**TOWN OF ACTON**  
472 Main Street  
Acton, Massachusetts, 01720  
Telephone (978) 264-9628  
Fax (978) 264-9630

**Subject: Peet P.C.R.C. - "QUARRY WOODS"**

We have reviewed the above-mentioned plan dated June 21 2006 and have the following comments.

**Subject:** PEET P.C.R.C – “QUARRY WOODS”

### TYPICAL BICYCLE & PEDESTRIAN TRAIL

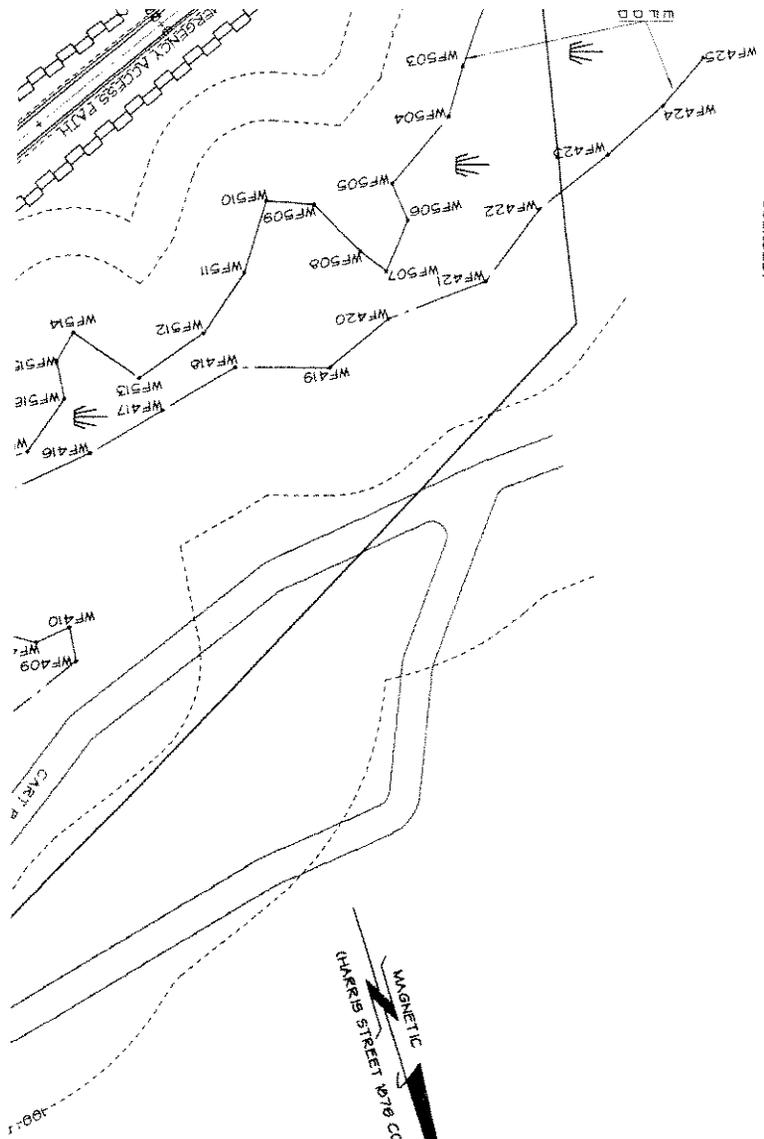
27. The engineer should add some notes and details to the plan clearly stating that the contractor will reconstruct the existing cart path at the crossing of the proposed driveway at about Station 3+75 to provide a smooth safe path of travel for pedestrians, bicyclists, etc... Attached is a copy of the typical cross section for the existing cart path. At a minimum, the reconstructed ends of the cart path need to at least match the specifications shown in this detail.
